National Trust submission relating to DA/960/2022

The National Trust of Australia (NSW) expresses its strong objections to the proposal for MBC House at 188 Church Street Parramatta.

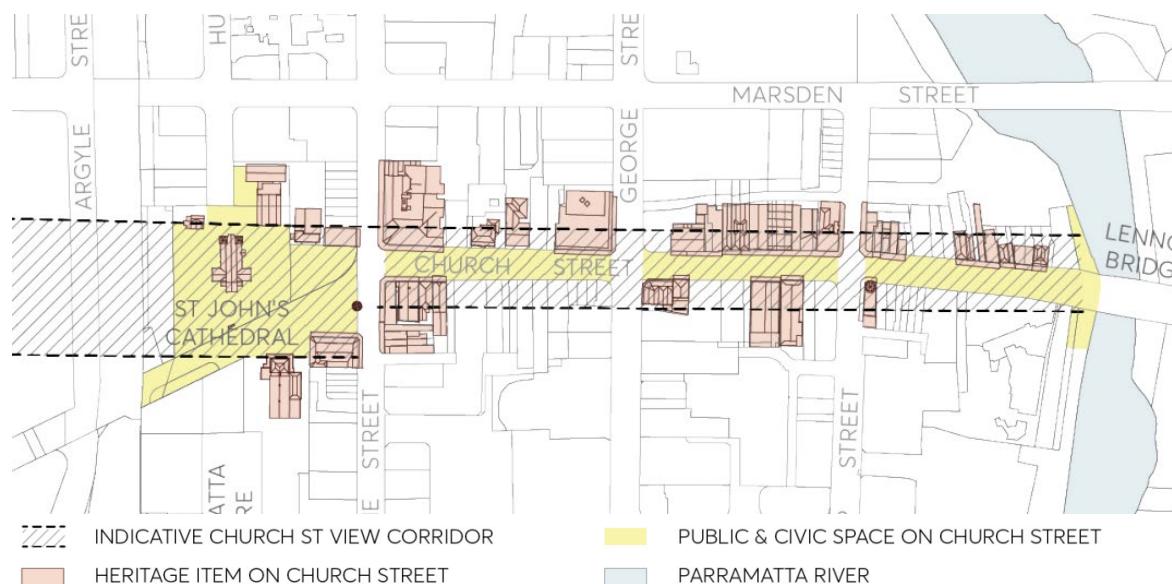
As the above guidelines and figure 6.5.4.1 from the DCP shows below, the development controls for the Church Street View Corridor and Centenary Square are very clear. The Built Form Study (p.15) by TKD Architects acknowledges that this site sits within the bounds of the corridor as indicated in the DCP.

Put simply, it is the opinion of the National Trust that this proposal is not consistent with the planning controls and objectives for this area. This site is clearly a heritage item within the defined view corridor, and the current height of 2-3 storeys is exactly the scale which contributes to the character and setting of Centenary Square.

Proposed building impact on Parramatta Town Hall (TKD Architects)

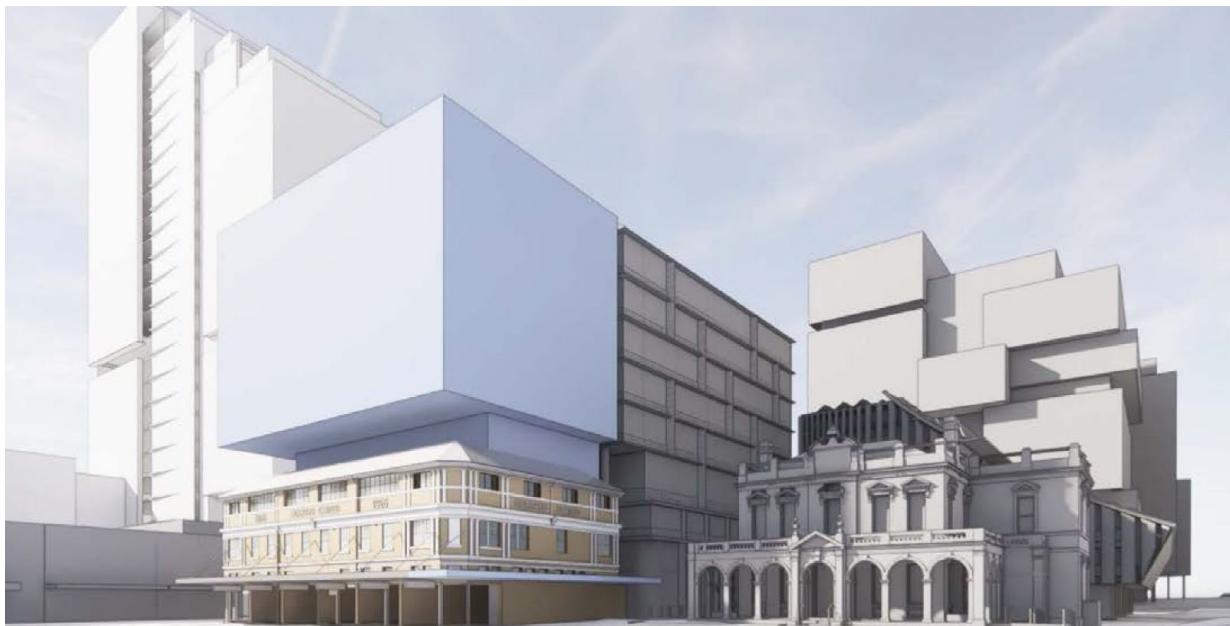
The National Trust are at a loss to understand how it can be claimed in the Heritage Impact Statement (p.74) that the visual relationship between the Murray's Building and Parramatta Town Hall is *“only fully visible in the winter months”* due to some London Plane trees planted in the square. This proposal reduces the visual prominence of the Town Hall dramatically and we would disagree that there is *“an appropriate separation between the new addition and the Murrays’ Building ensure that the relationship between the two buildings is retained.”*

This proposal, through its placement directly above an existing listed heritage building of similar scale to the Parramatta Town Hall, will completely overwhelm any sense of historic setting that this important civic building might otherwise retain. It will directly overshadow the area in front of this building at midday, and provide a sense of overbearing, rather than of openness, to this public space.

The adjacent building to the north of the Town Hall that is nearing construction will of course have some impact to this setting, but the dramatic intrusion of this proposed new building in front of the Town Halls’ building line will have an even greater negative impact on this area which the DCP Church Street View Corridor specifically sought to protect.
